**Appleby Creek Flood Mitigation
Schedule B Class EA
Addendum Report**

Prepared For:
City of Burlington

**July 2024
300057084.0000**

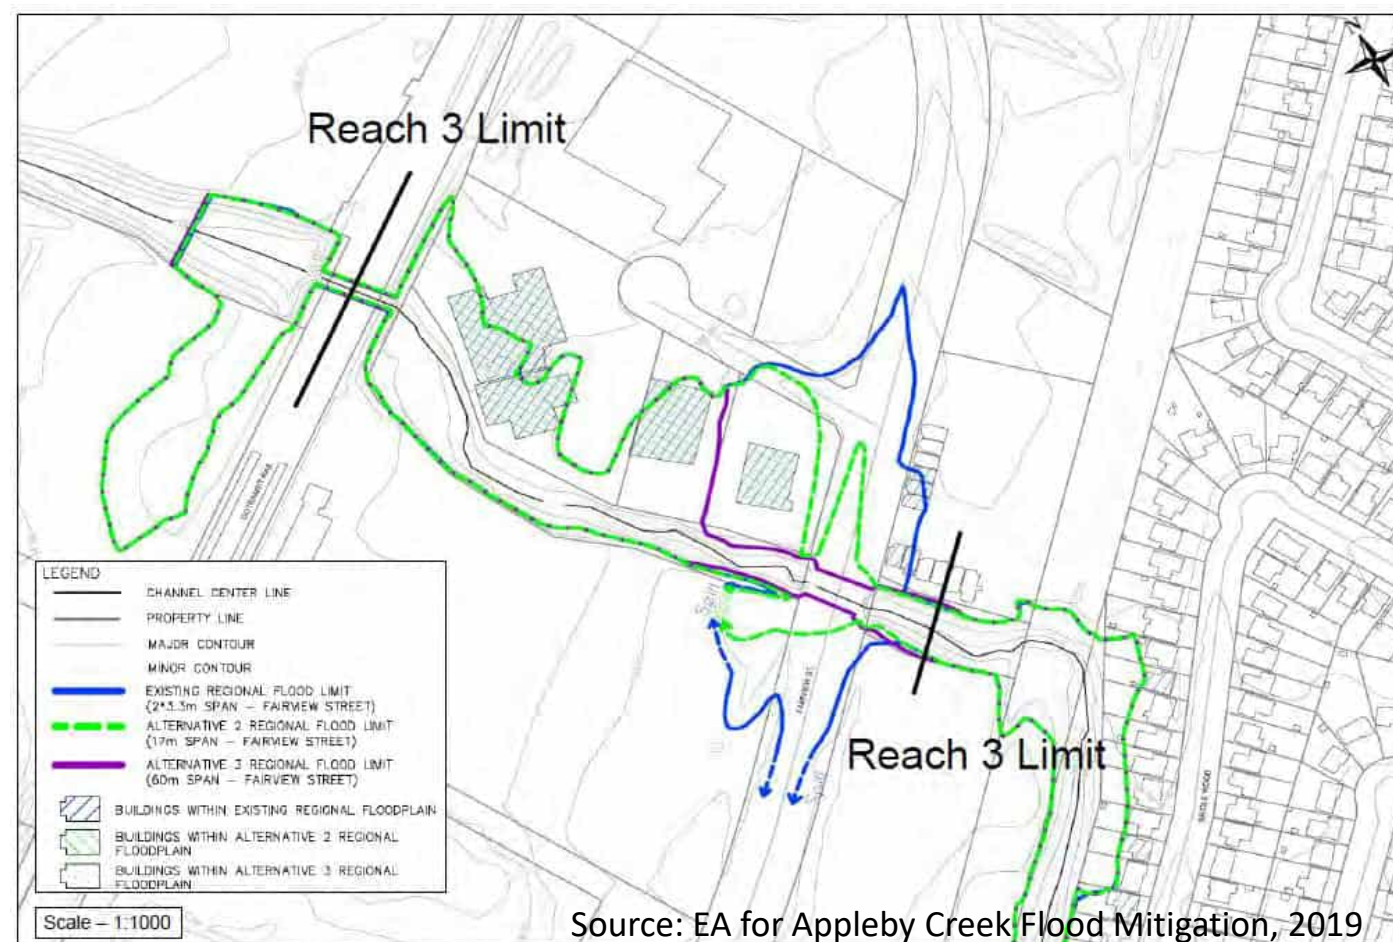
Revise Score from 0 to 3
The disruption for reconstruction of the road in either case is similar in application and duration.

Revise Score from 0 to 3
The review of current cost estimates indicate the variance between the cost of a structure to convey a region storm vs a 100 year storm is <5%
Additional cost may be off set by development charges.

Revise Total Score from 61 to 68

2019 MCEA Preferred Solution (Option 2)

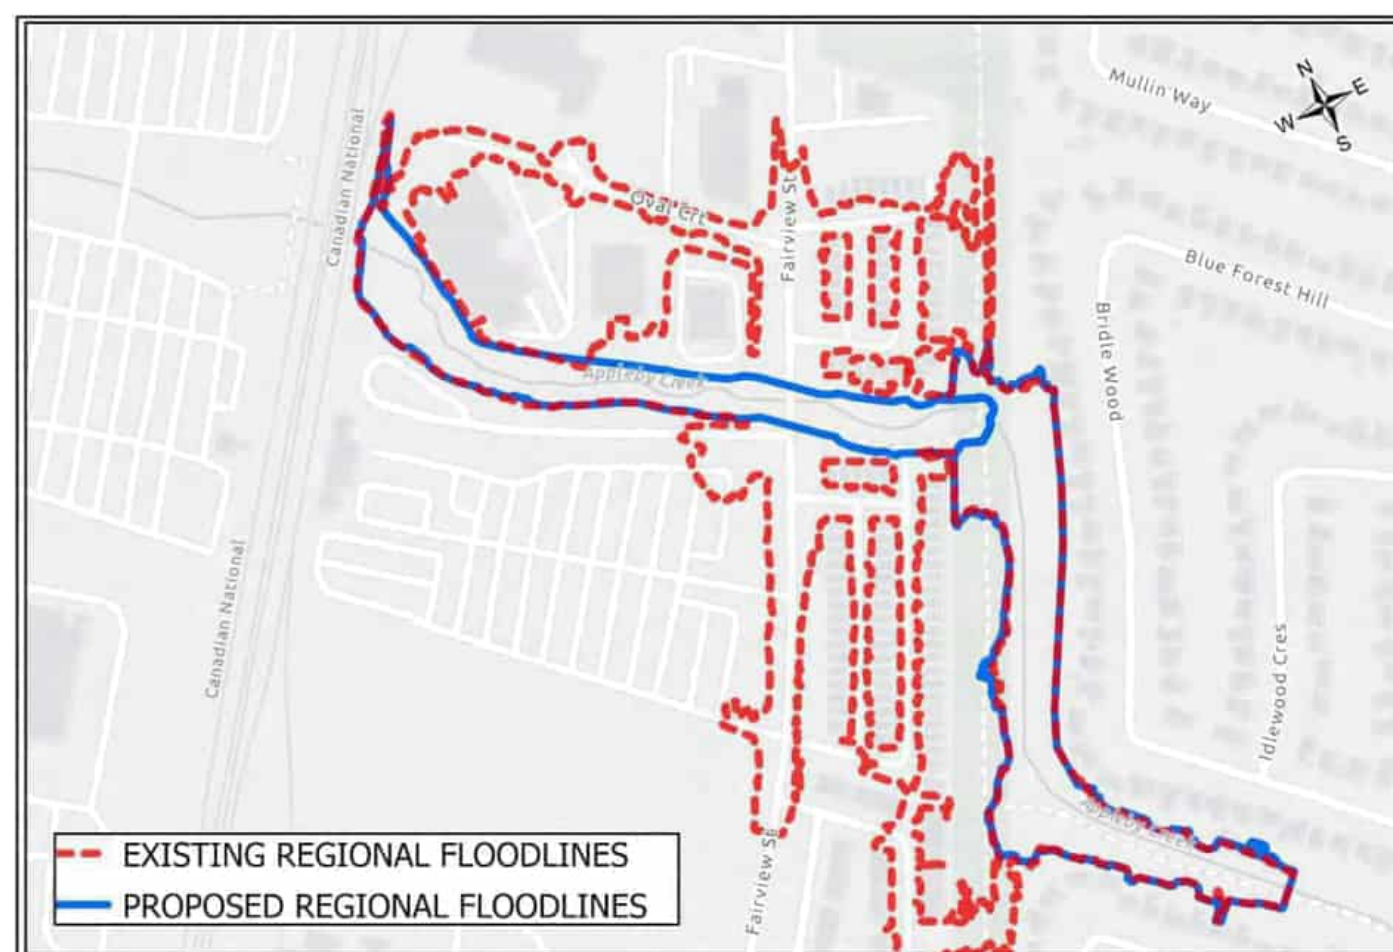
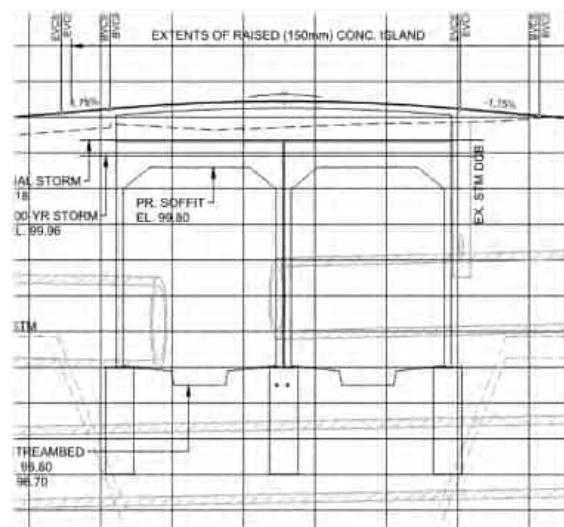
- Fairview Street crossing structure 17m wide to pass the 100-year storm
- maintains the existing road surface elevation
- four (4) buildings on the Oval Court Lands would be located within the Regional floodplain
- water would overtop Fairview Road under Regional storm conditions

- Fairview Street crossing with a larger span structure to pass the 100-year storm and Regional storm conditions
- Minor grade elevation increase on the road surface depending on type of structure selected. Adjacent driveway and may require restoration.
- Existing and proposed buildings on Oval Court lands would be removed from within the Regional floodplain.
